SERVICE BULLETIN REVISION NOTICE

ENGINE FUEL AND CONTROL — CONTROL, ELECTRONIC ENGINE (EEC) — REPLACEMENT
OR MODIFICATION OF, TO INCORPORATE SCN22/AB SOFTWARE CONFIGURATION

Turbojet Engine Service Bulletin No. V2500-ENG-73-0236 Revision No. 1 dated May 7, 2019.

V2500-ENG-73-0236

LOCATION OF THE EEC
73-22-34
FIGURE 1

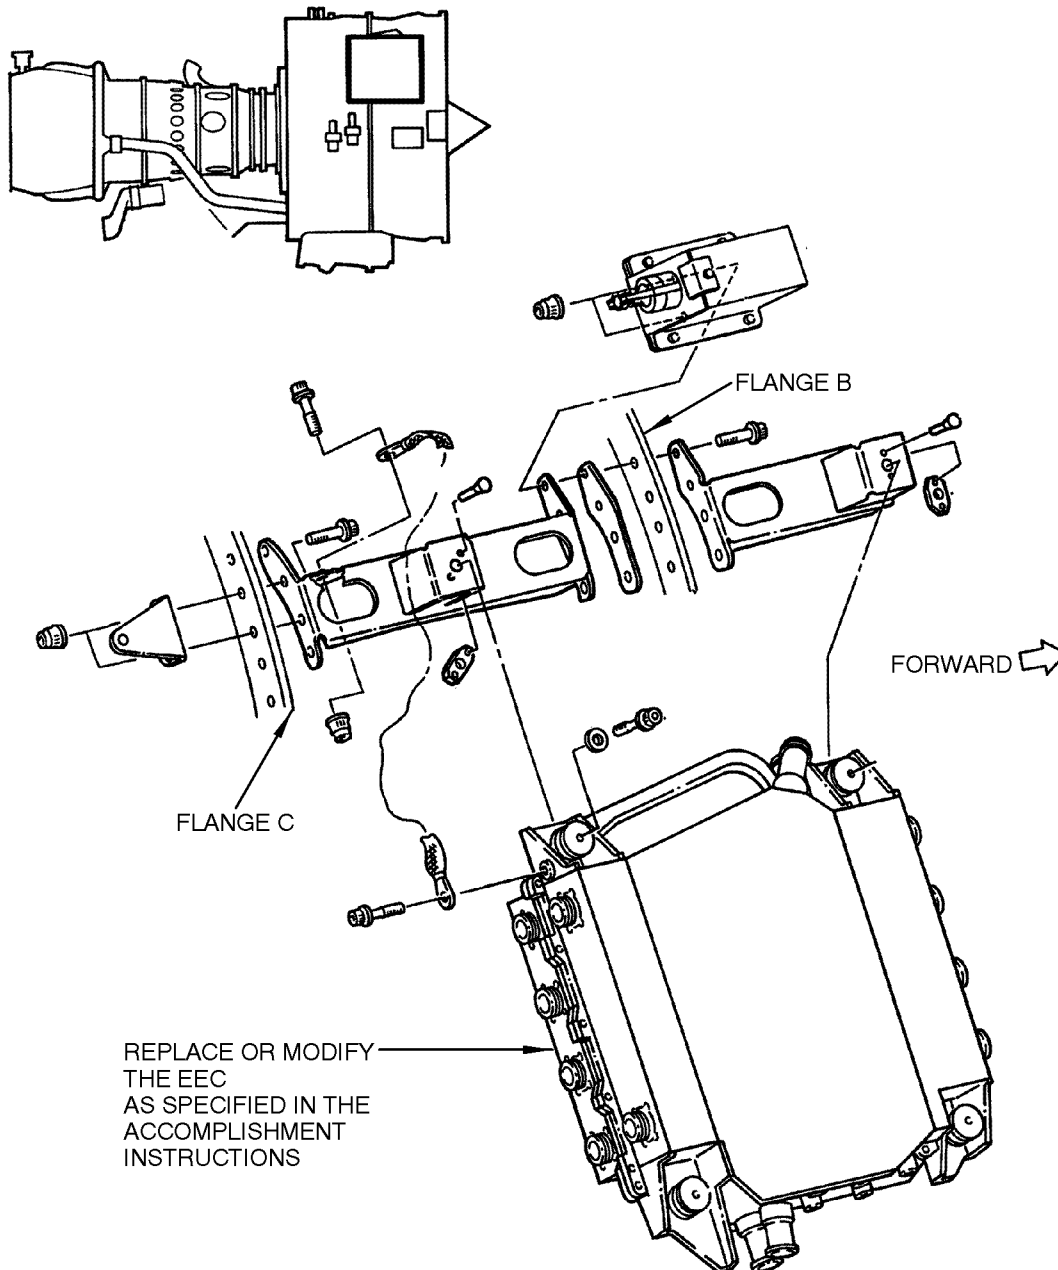
1. Replace or do a modification of the EEC by the procedure that follows:
 - A. Replace the EEC as shown in Table 2 or do a modification of the EEC as follows. See Figure 1.
 - (1) Send the part to the vendor listed in the Vendor Services section. The modified EEC will be returned identified as given in Table 2 below. Remark EEC PN as given in Table 2 below.

- (1) Remove the EEC harness connector from J1, J3, J7 and J9.
- (2) If desired, remove the EEC as specified in Reference 7, Airbus Service Bulletin A320-73-1104. See Figure 1 for the location of the part.
- (3) Install Software per software loader Reference 10, Service Bulletin V2500-ENG-73-0238.

EEC
CHART A

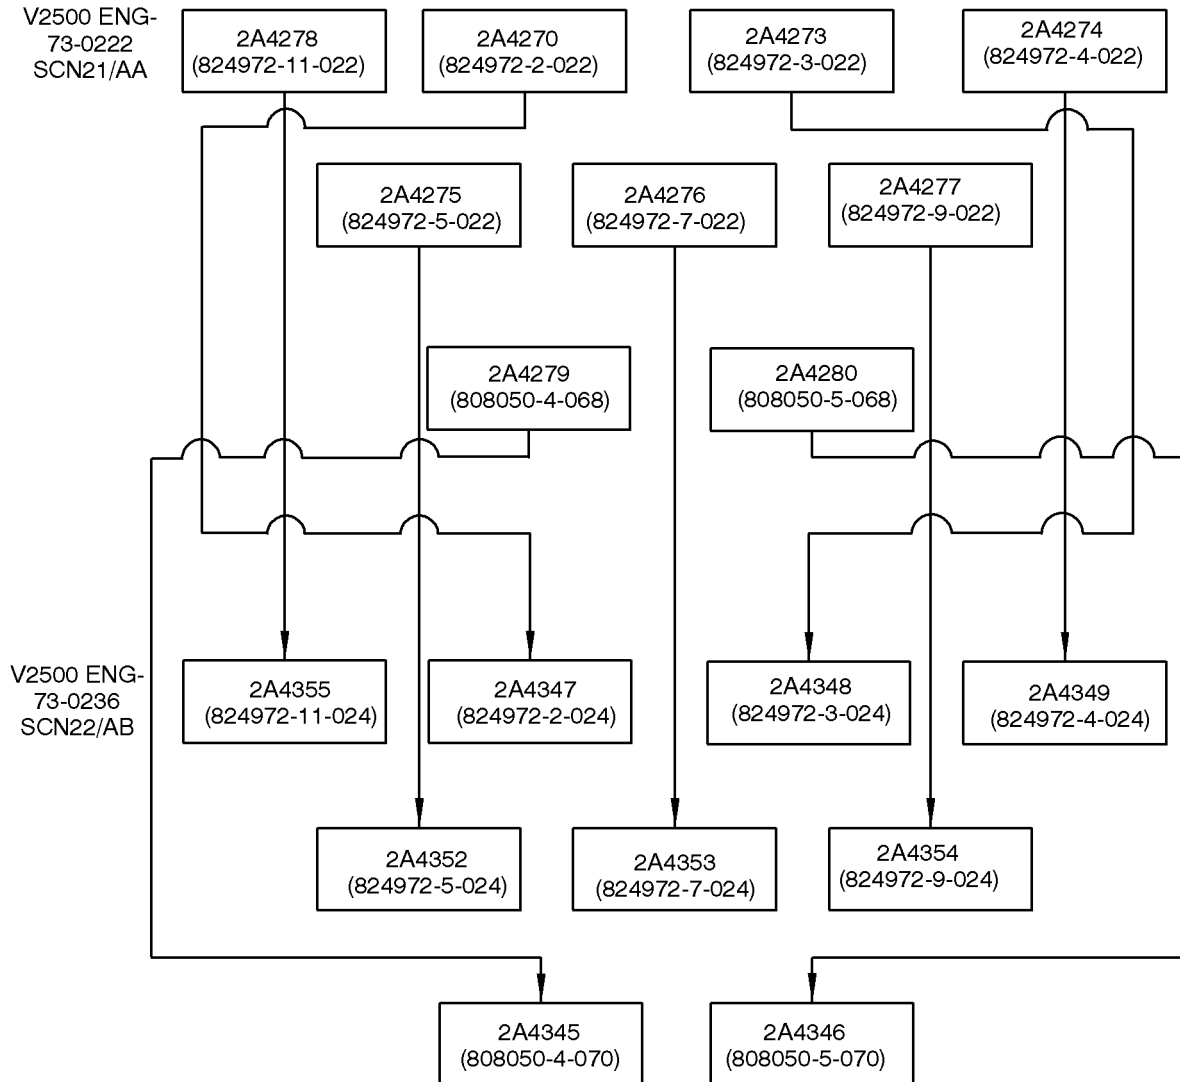
Parts Progression To Show the Changed Part in Relation to Other Parts
